ADDENDUM #2

Rye City School District

Osborn Elementary School

Midland Elementary School

1 Corner Detail A
SCALE: 1 1/2" = 1'-0"

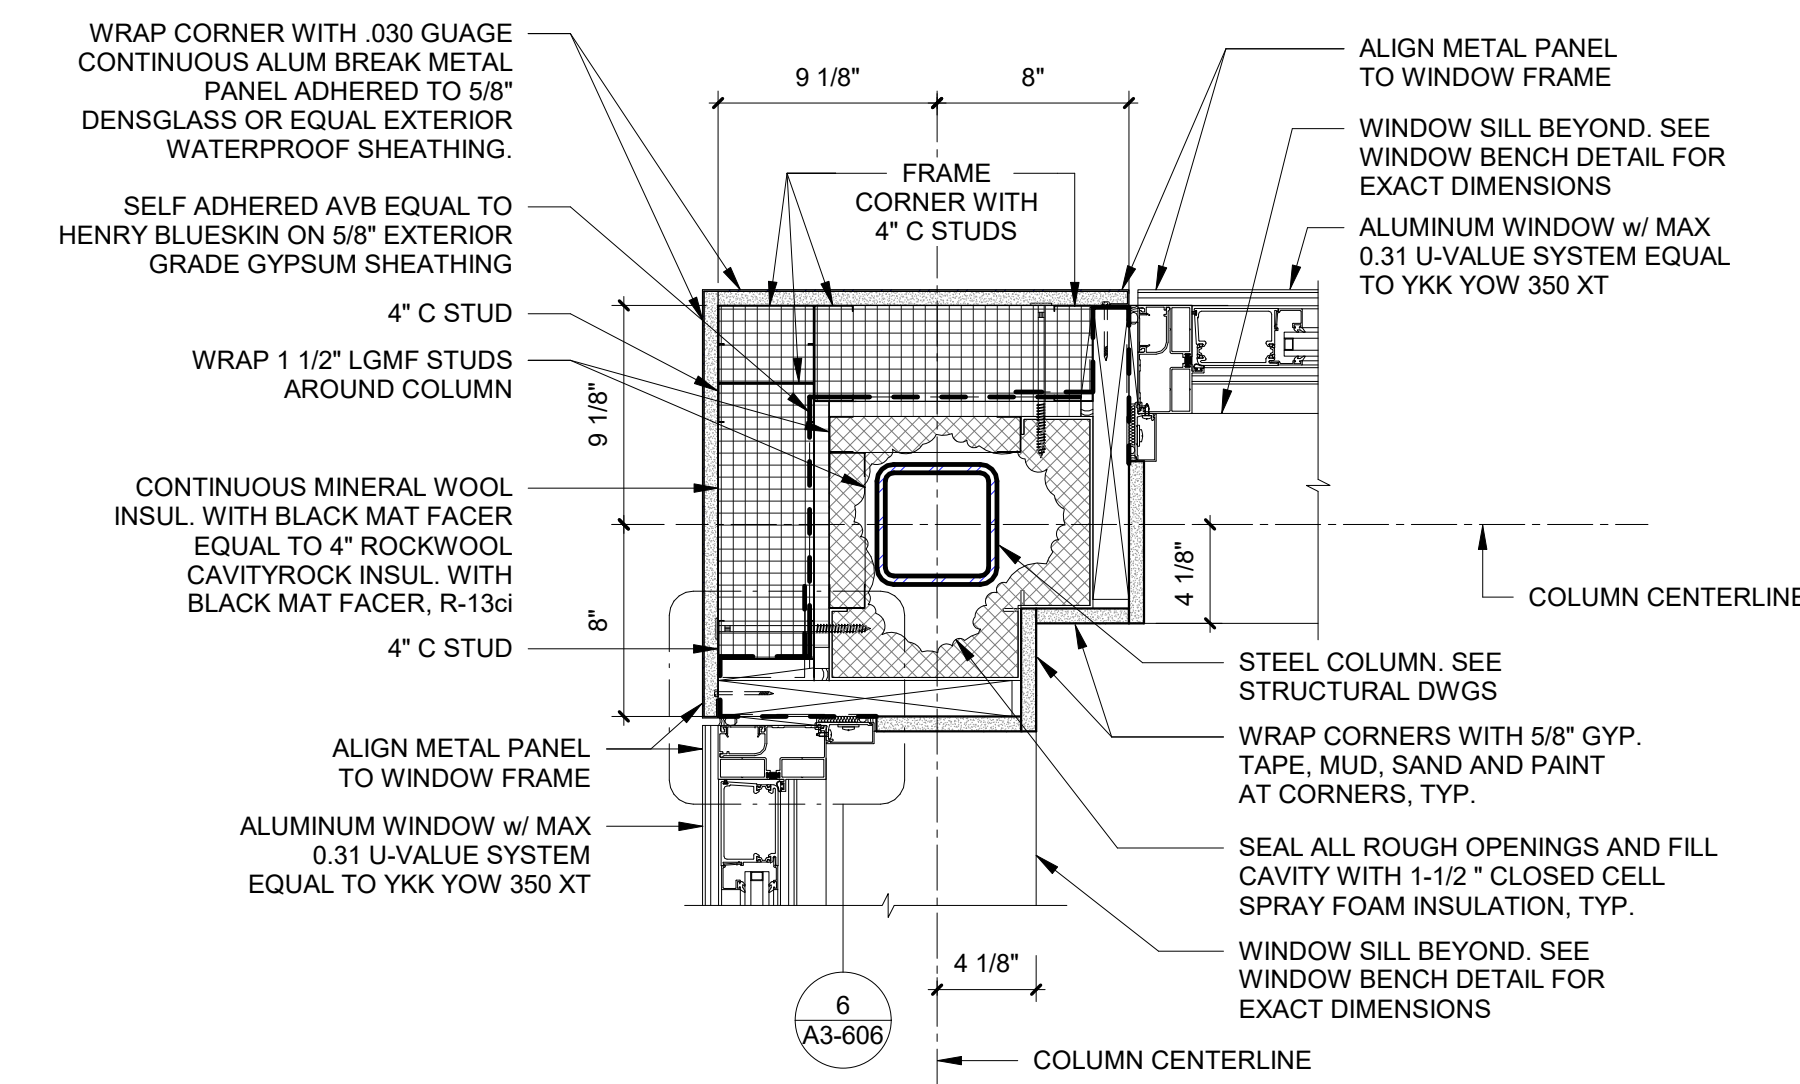
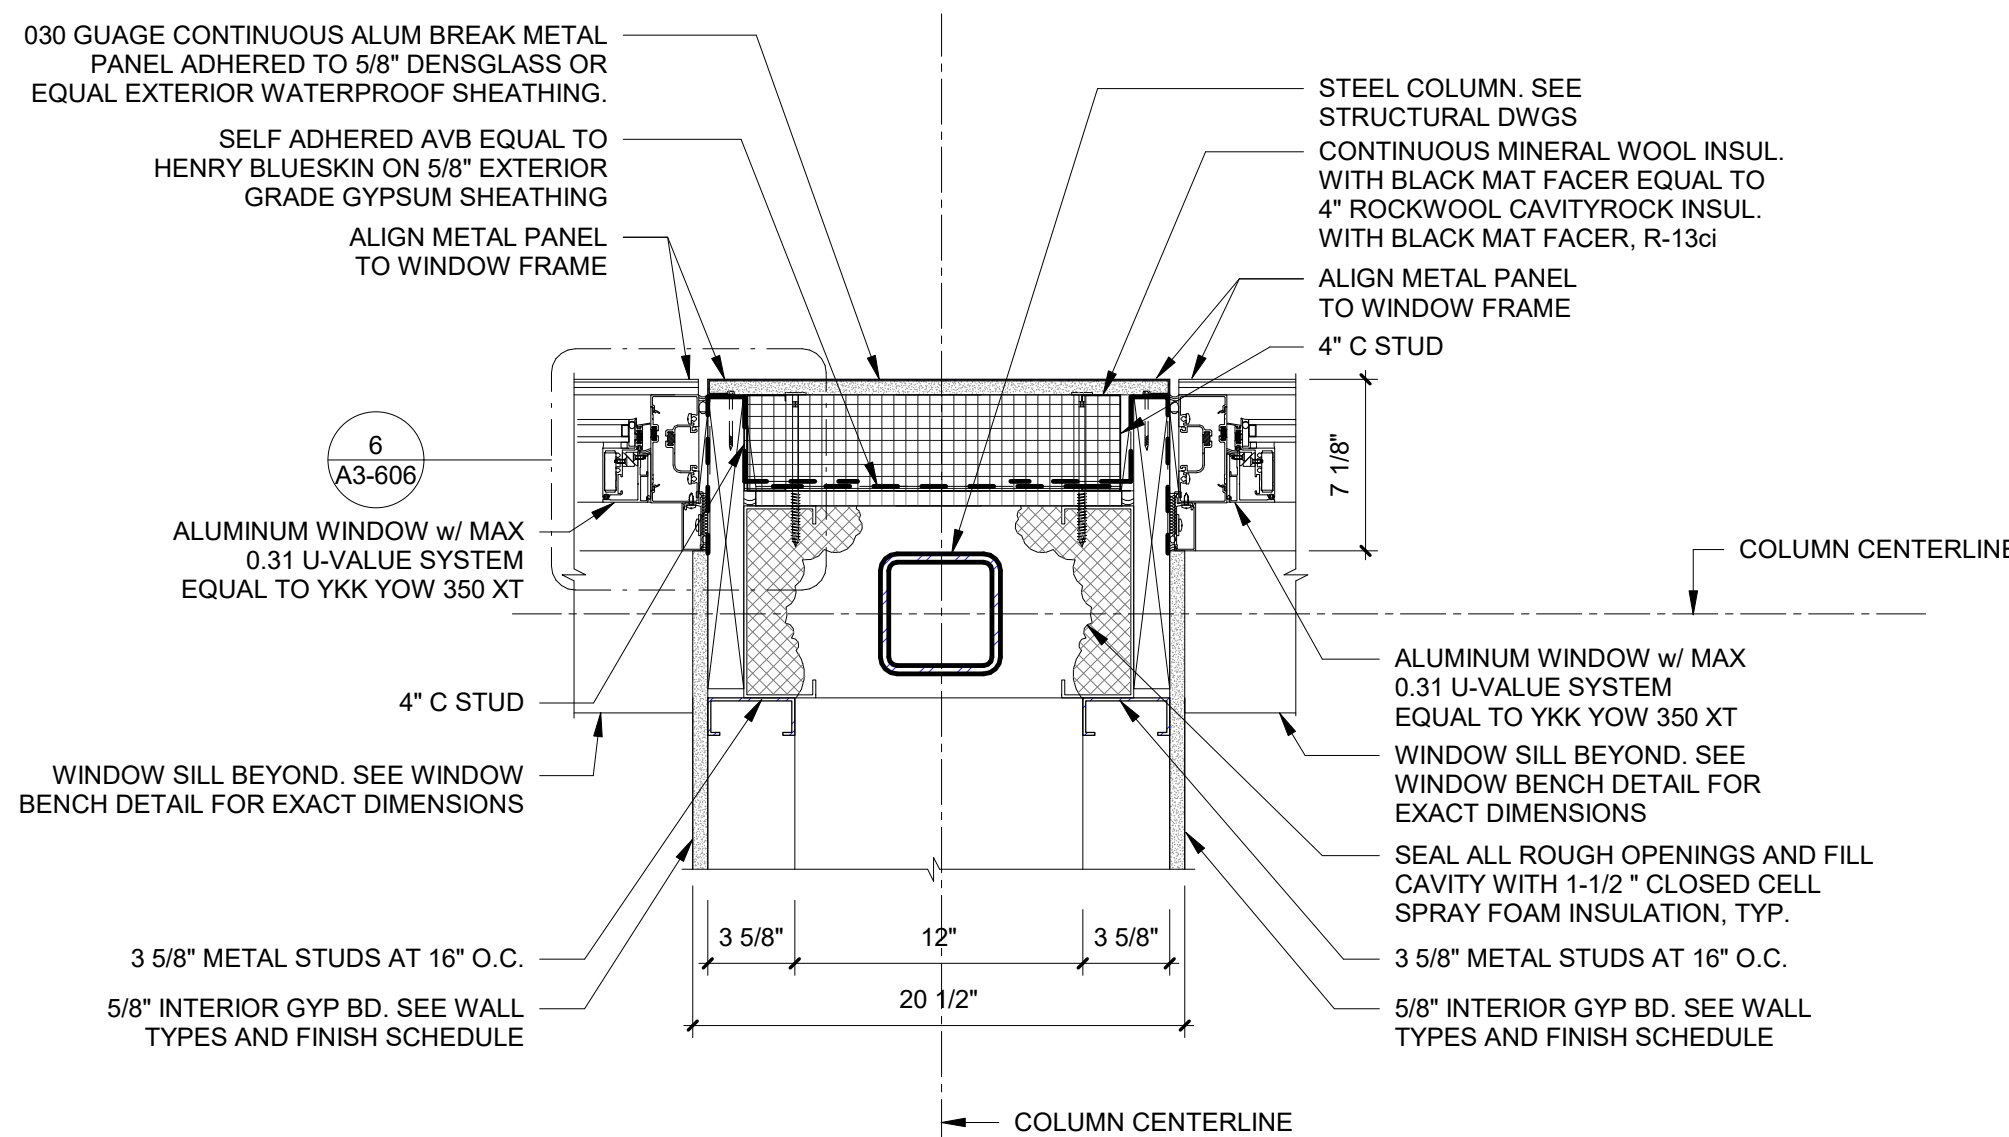
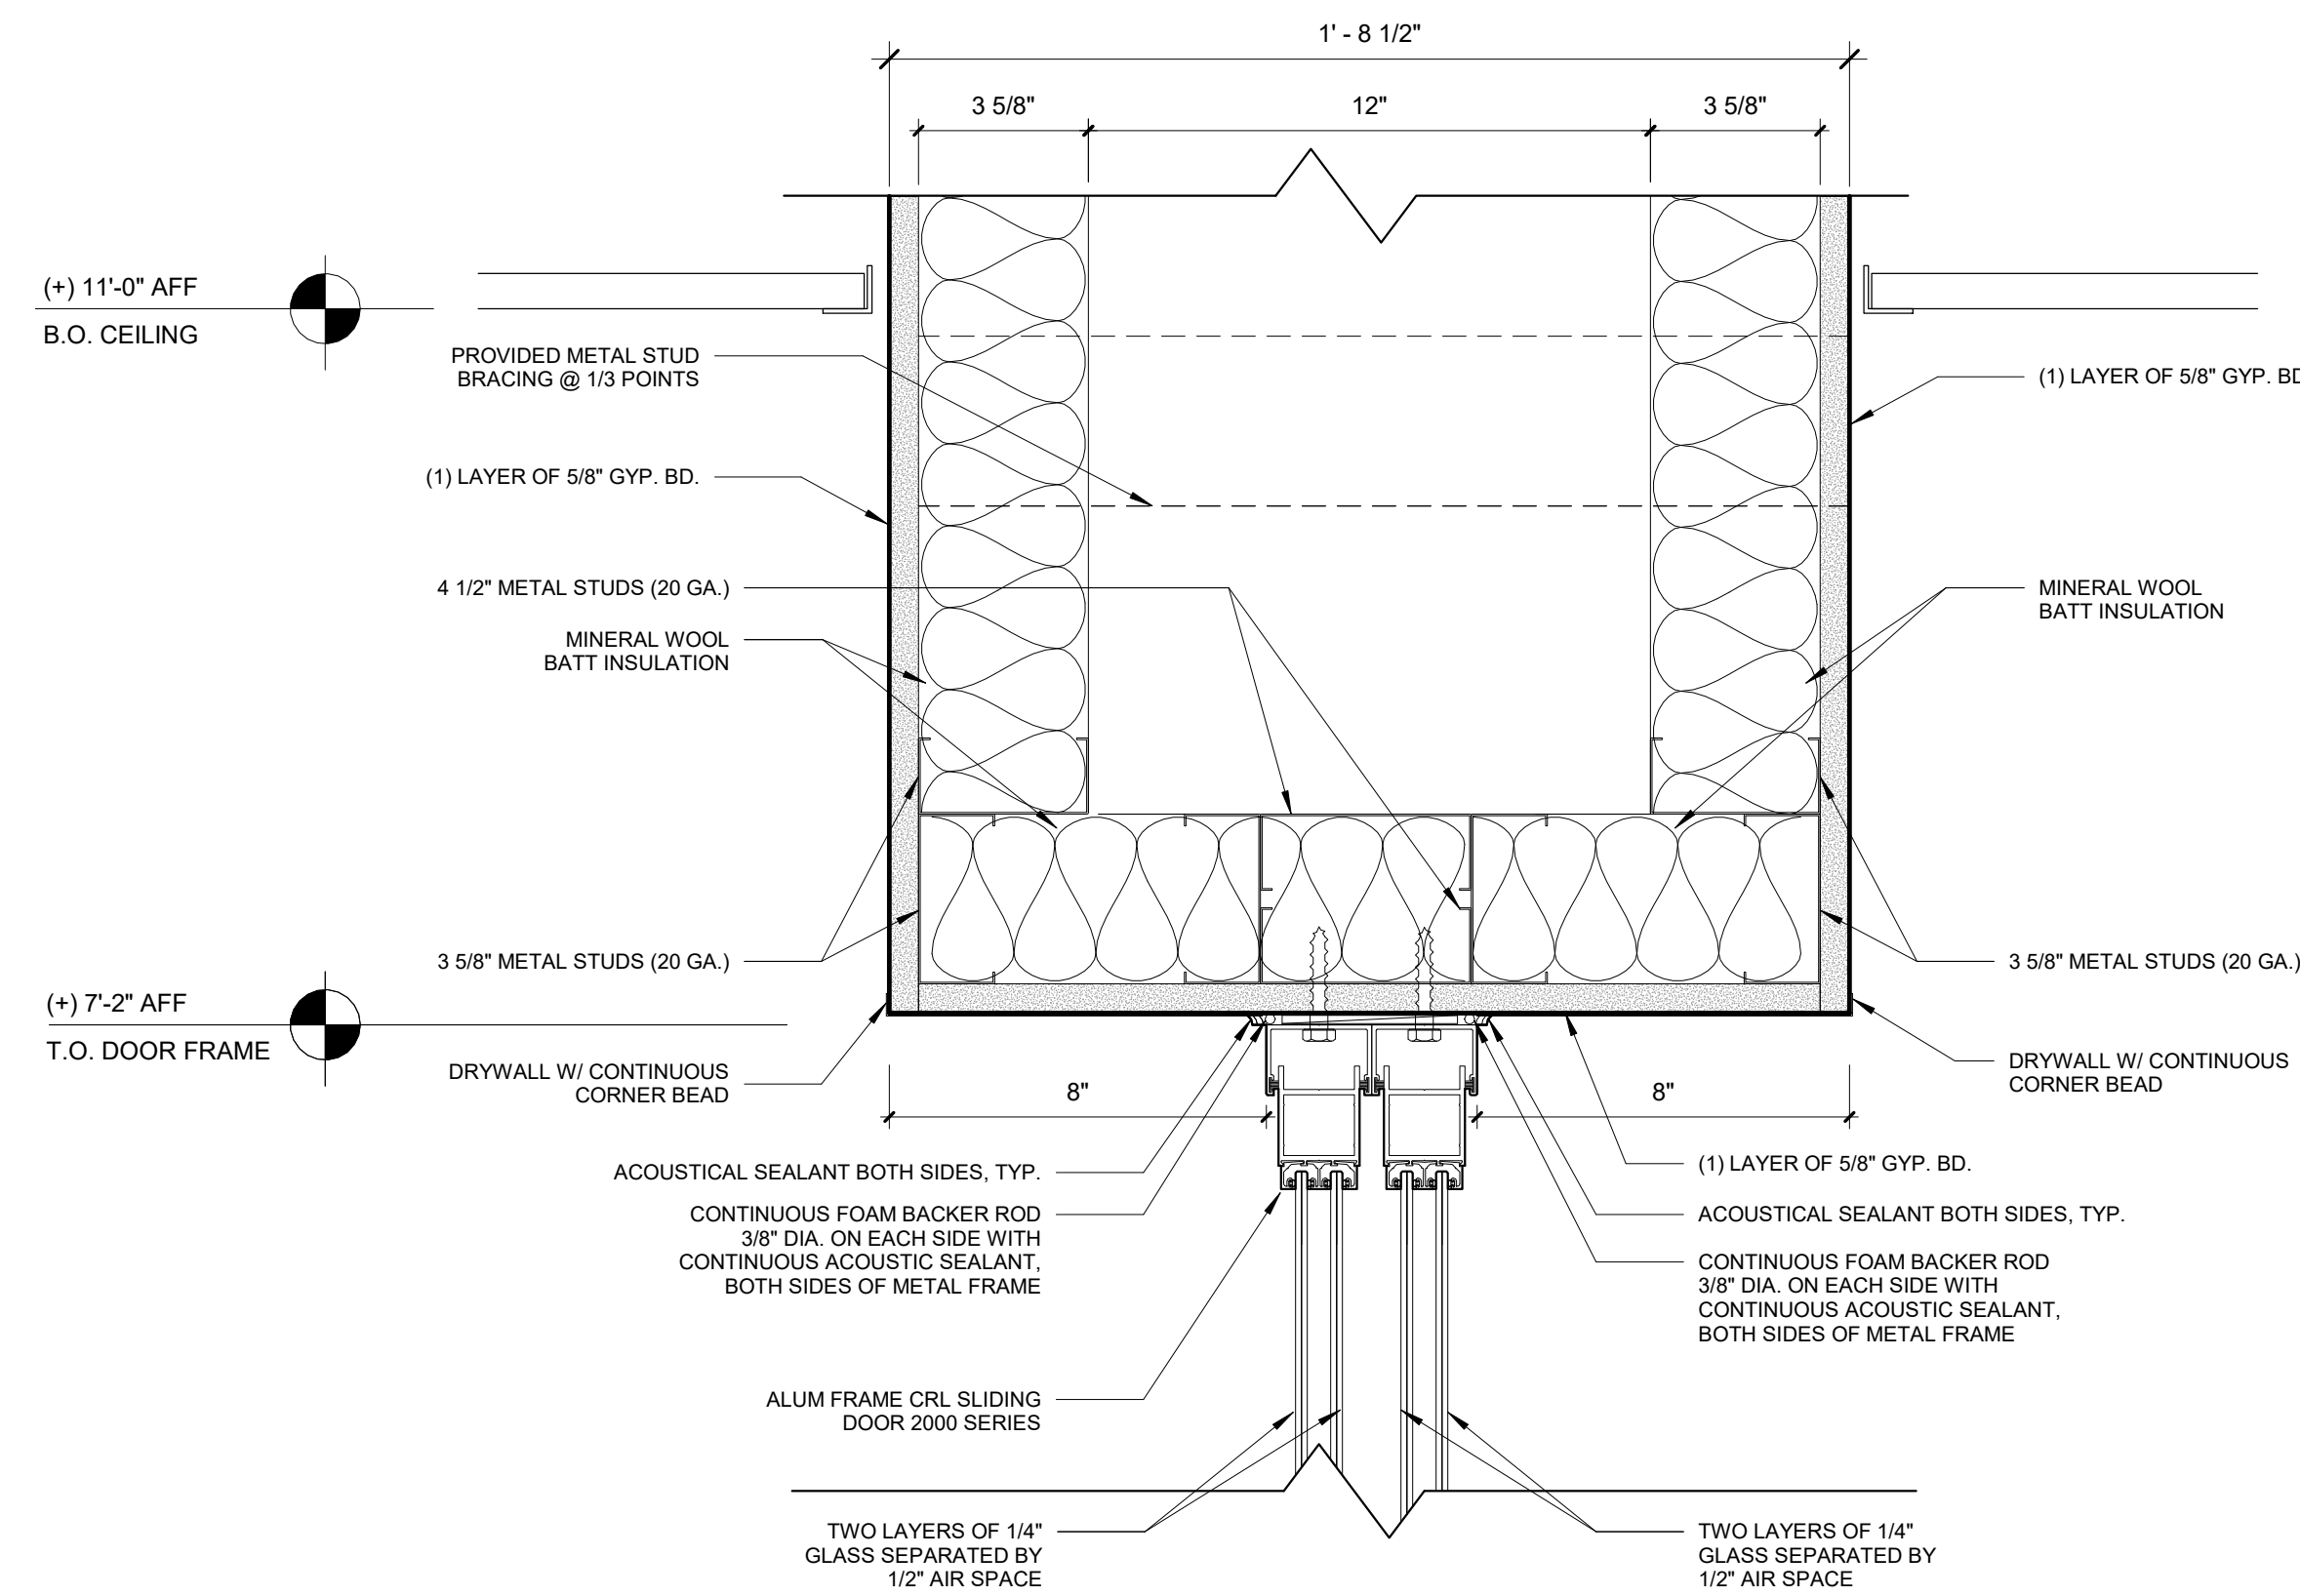
- a. Door head and jamb details added
